STATE OF OREGON
DEPARTMENT OF ENVIRONMENTAL QUALITY

PERMIT NO. 98-112

Re: OSS: NWR: Clatsop County: Site Evaluation Report: Twn 4N, Rng 7W, Section 4,
Tax Lot 605: 5.16 Acres

Re: OSS: NWR: Clatsop County: Site Evaluation Application: Twn 4N, Rng 7W, Section 4, Tax Lot
605: 5.16 Acres

TWN 4N
Rng 7W
Sec 4

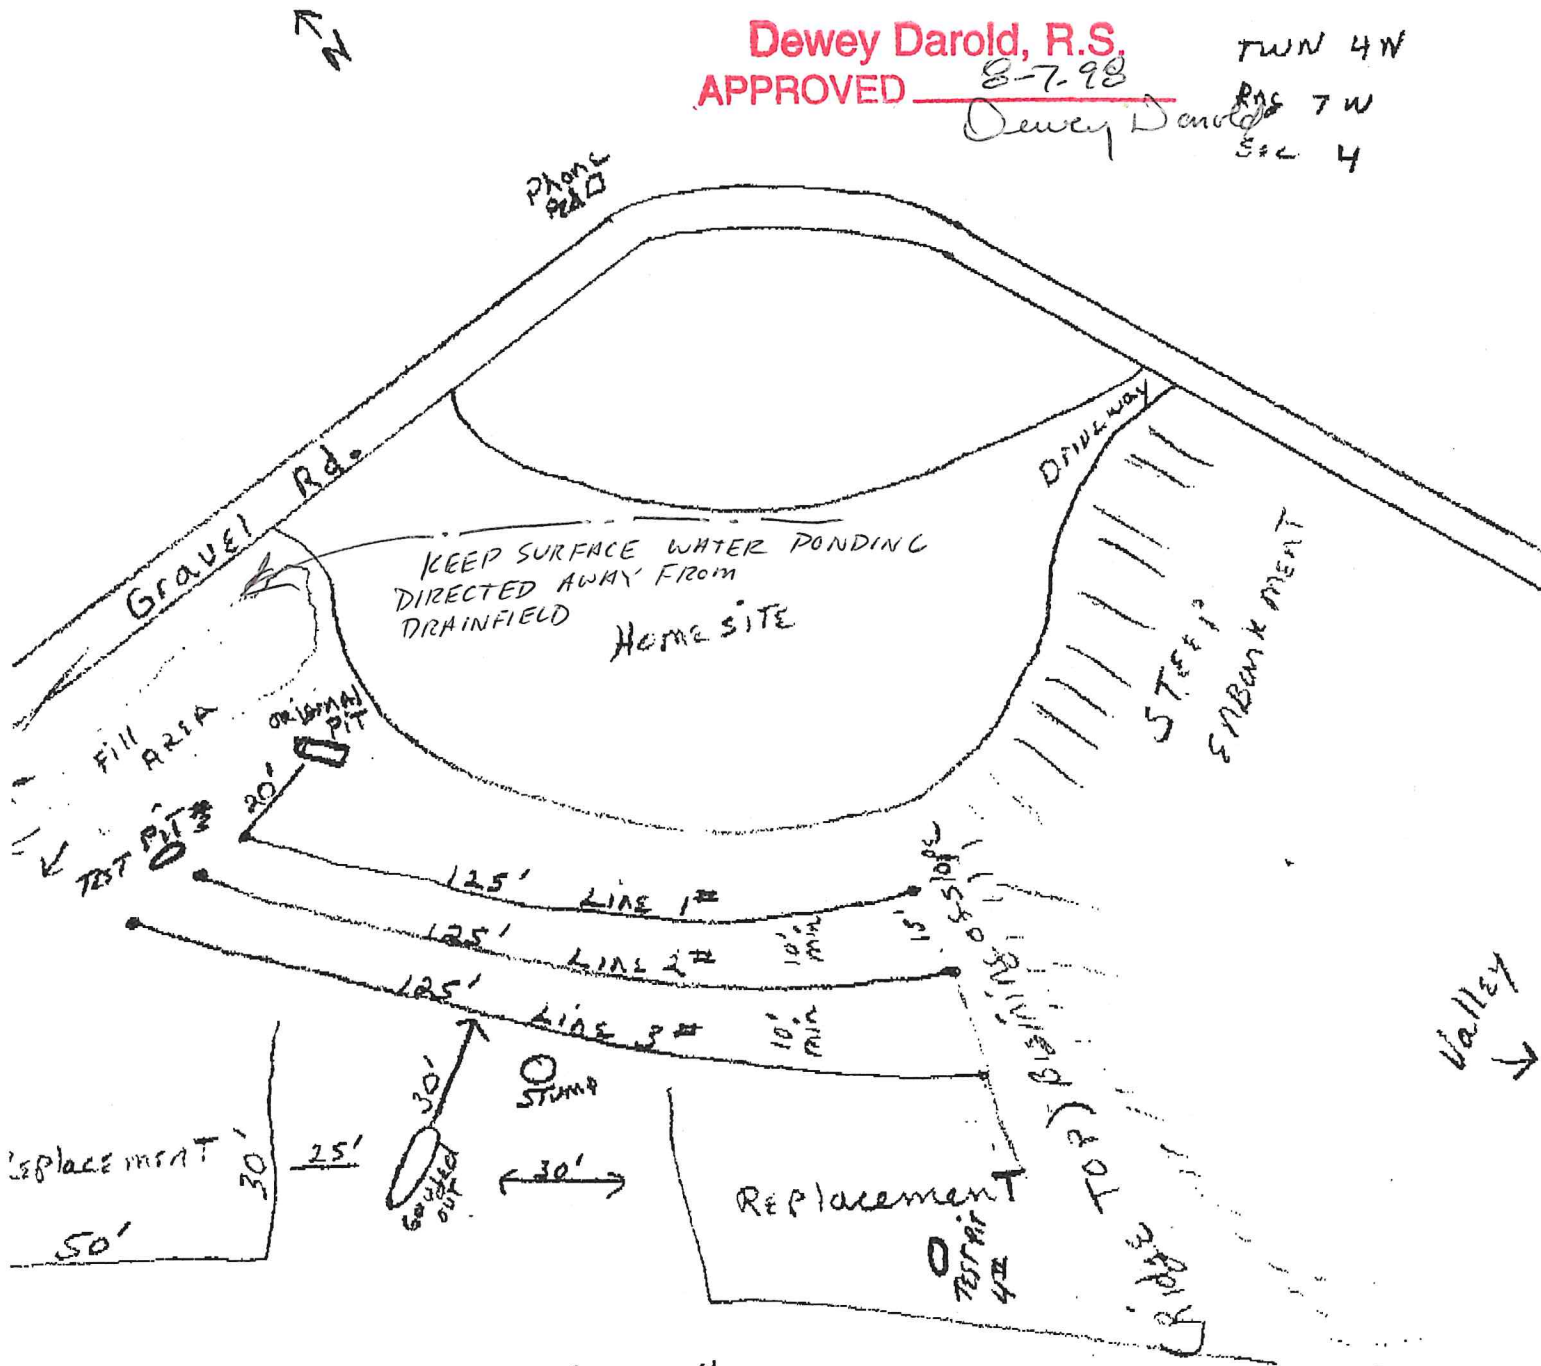
"Drainfield staked out"

Following contour of ground TRENCHES will
maintain required min-max depths

2 NEW TEST PITS ON SITE

Dewey Darold, R.S.
APPROVED 8-7-98

GORDON SMITH
407-4-605
5.16 Acres

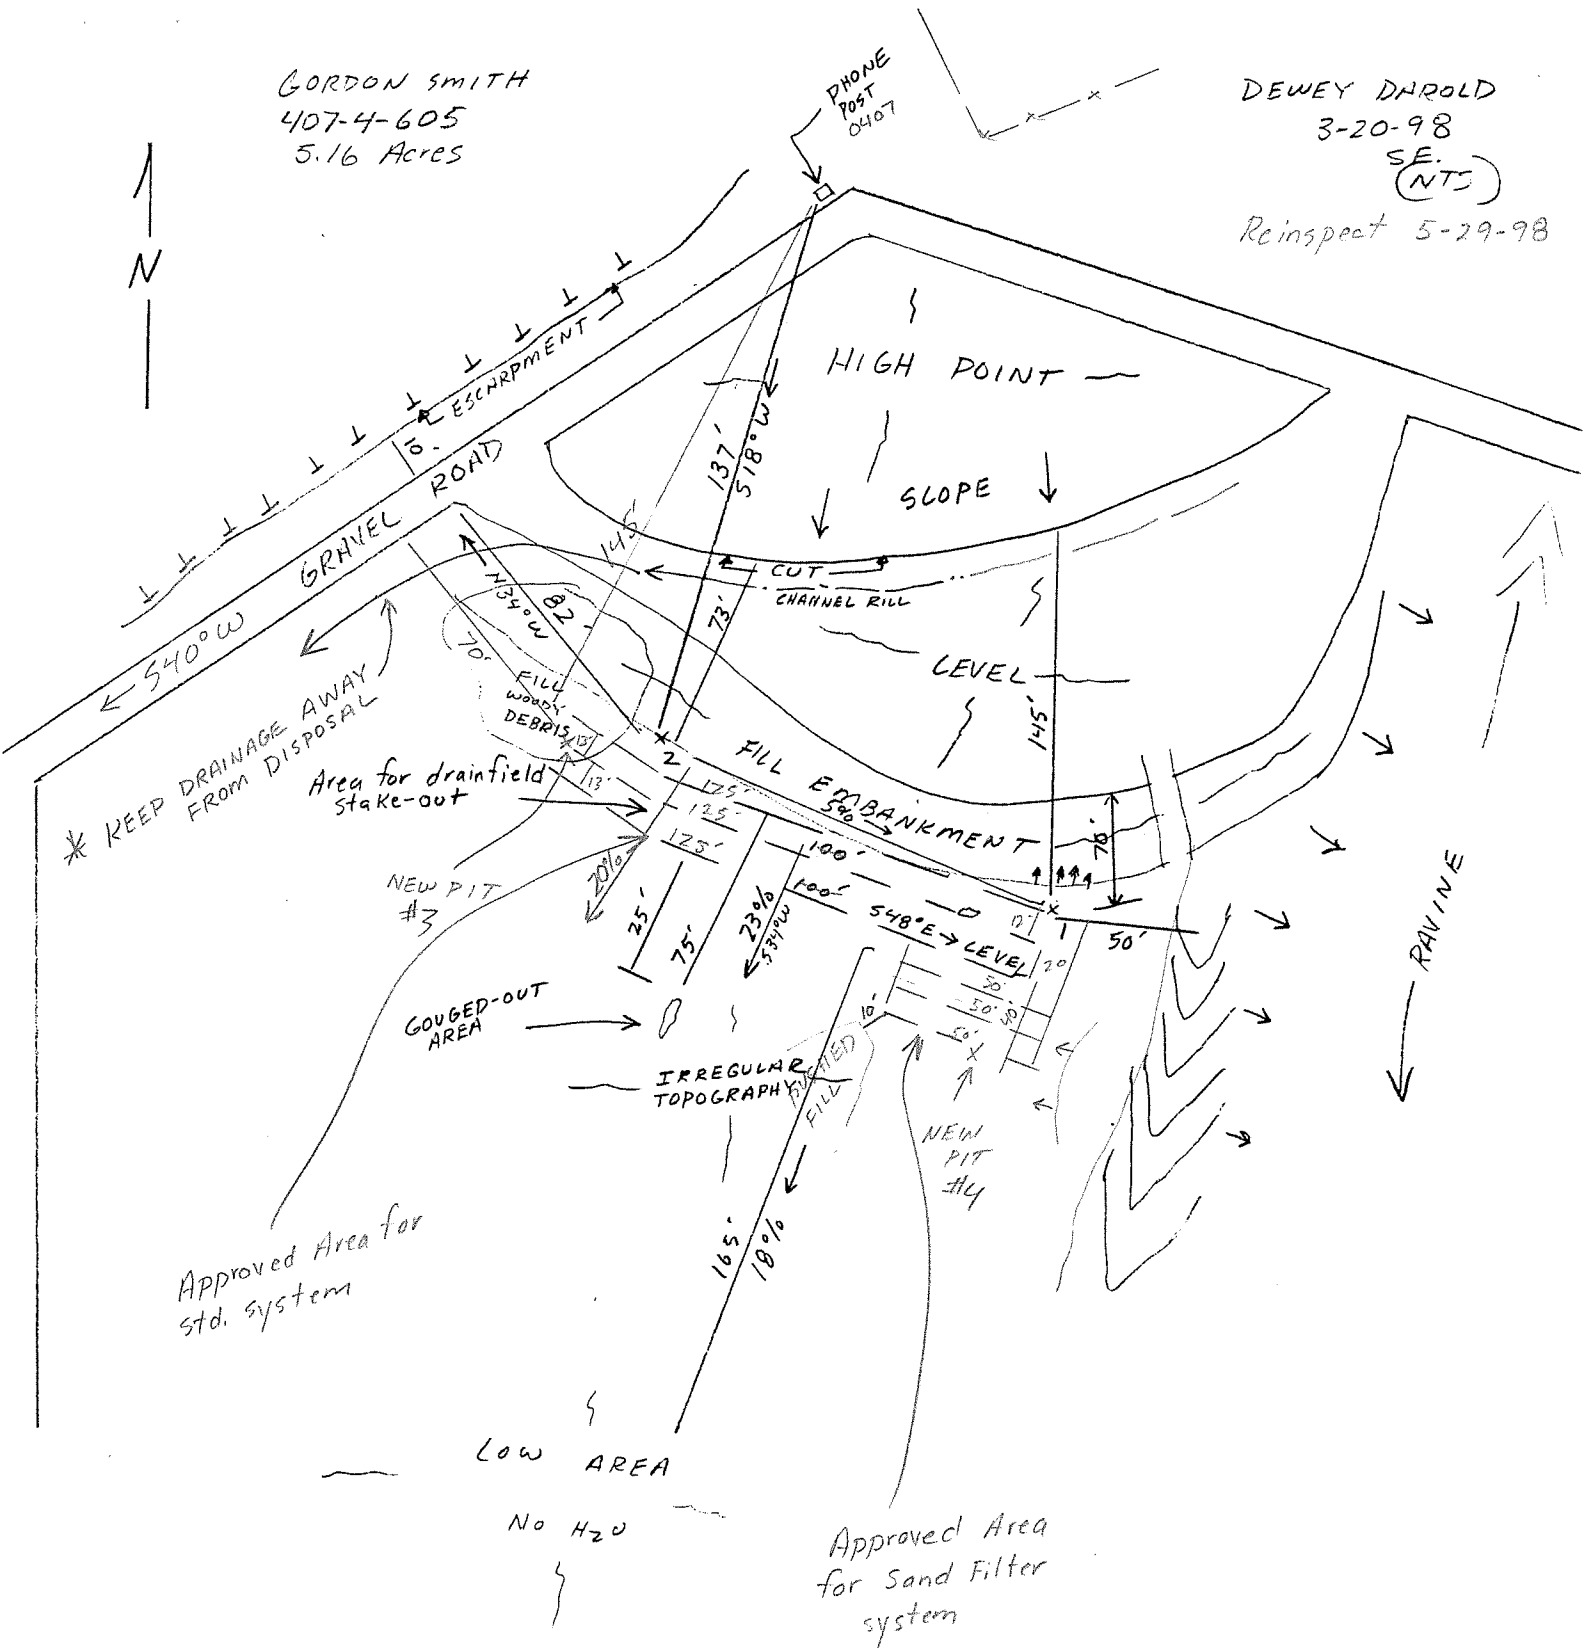
Two new test pits were prepared on the property. Three one-hundred and twenty-five foot long disposal trenches were staked-out for review. The trenches were directed approximately S48°E and found to be level from one end to the other. The downslope trench was placed above the area previously gouged-out. The natural slope in the area of the test pits averaged 20 percent. Both test pits showed soils to be deep and well drained.

Based upon the results of the study, the site was found to meet established criteria for a **standard serial distribution system for the initial system and a sand filter system for the replacement system**. Care must be taken to construct the system on this property. The system construction details will consist of a 1000 gallon DEQ approved watertight septic tank with a gasketed riser to ground surface. The drainfield will be sized at 125'/150 gallons per day (gpd) for a total lineal footage of 375 feet for the initial system. No more than three disposal trenches at 125 feet per trench should be installed. The trenches will be designed in serial distribution and limited to a minimum depth of 24 inches and a maximum depth of 36 inches. A sand filter replacement system is necessary due to the soil modifications that have occurred. It is important home downspouts be directed away from the drainfield. Also, the drainfield areas must not be subjected to excessive saturation due to, but not limited to, artificial drainage of ground surfaces at the building site and driveways.

Please refer to the enclosed soil field worksheet and site diagram for specific location of approved area boundaries. The future replacement sand filter system will be located adjacent to the initial disposal field and in the southeast portion of the initial drainfield.

GORDON SMITH
407-4-605
5.16 Acres

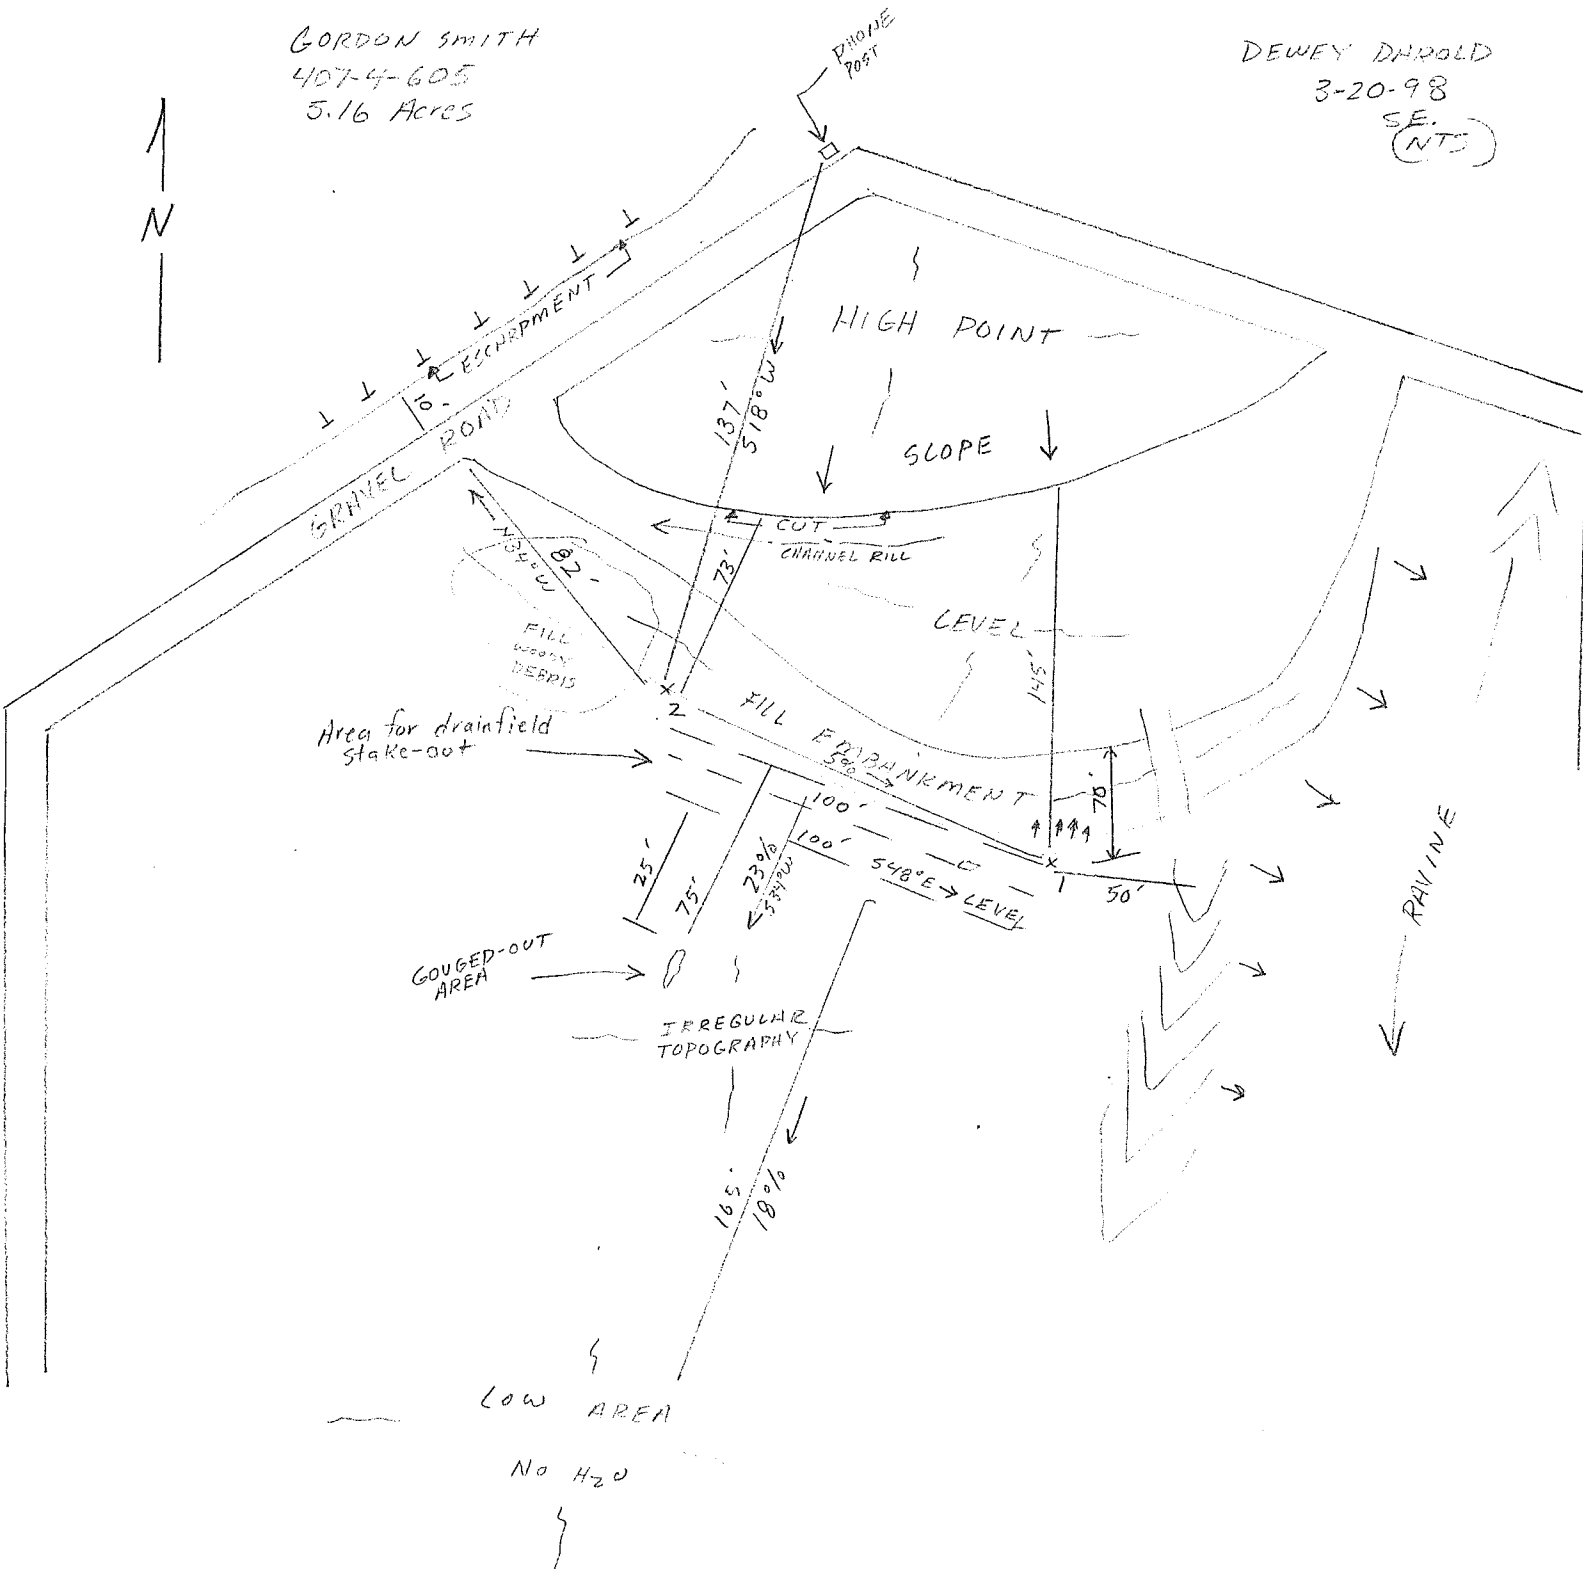
PLEASE NOTE: The soils in the vicinity of test pit # 2 have been filled and modified in a way that would adversely affect functioning of the system. Further, the top soil surface horizon within the proposed drainfield areas is compacted to a depth of approximately 10 inches below the ground surface. Test pit # 2 is unsuitable for sewage disposal since the pit has been dug in a fill embankment created along the edge of the level building site. The depth of fill inside test pit # 2 ranged from 15 inches on the downslope side to 26 inches on the upslope site. A gouged-out area is also present approximately 75 feet downslope of the test pits. This cut-out depression showed evidence of past surface water ponding probably due to an interface created from a fill layer lying over native soil. The gouged-out area extends for about 10 feet and is 30 inches deep on the upslope side and 20 inches deep on the downslope side. This area is also unsuitable for sewage disposal.

A standard serial distribution system was considered for this property. However, due to limited approvable area, modification of natural soil conditions from logging and/or clearing activities, there is inadequate area to install two complete standard subsurface sewage disposal systems in the area you have proposed.

A sand filter can be approved on this property. If you wish to seek approval for a standard on-site sewage disposal system, additional site preparation is requested. Please provide the following:

- 1) Please stake-out both the initial and replacement disposal fields. A standard system will require staking 375 linear feet of disposal trench. A sand filter will require staking 150 linear feet of disposal trench. Provide ground surface elevations (24 inches minimum and 36 inches maximum) at least every three points along each trench and clearly stake-out trenches (color coded) at beginning, ends, and every 25 feet in-between. The fill area (test pit # 2) and the gouged-out areas must be avoided. A 25 foot setback to the downgradient gouged-out area from the drainfield is required. Other areas of the property may need to be explored for sewage disposal.
- 2) Provide additional test pits that accurately reflect soil conditions in both the proposed initial and replacement drainfield areas.

All construction detail and setback requirements must be met. Please refer to the enclosed site diagram for information concerning the area where a portion of the drainfield stake-out is to occur. A preferably to-scale plot plan with the information requested in # 1 above should be submitted to this office prior to reviewing the site again. No additional fees will be incurred if you contact our North Coast Branch in Warrenton within 90 days from the date of this report and request another inspection. If we do hear from you within 90 days, a sand filter system will be approved for this property.
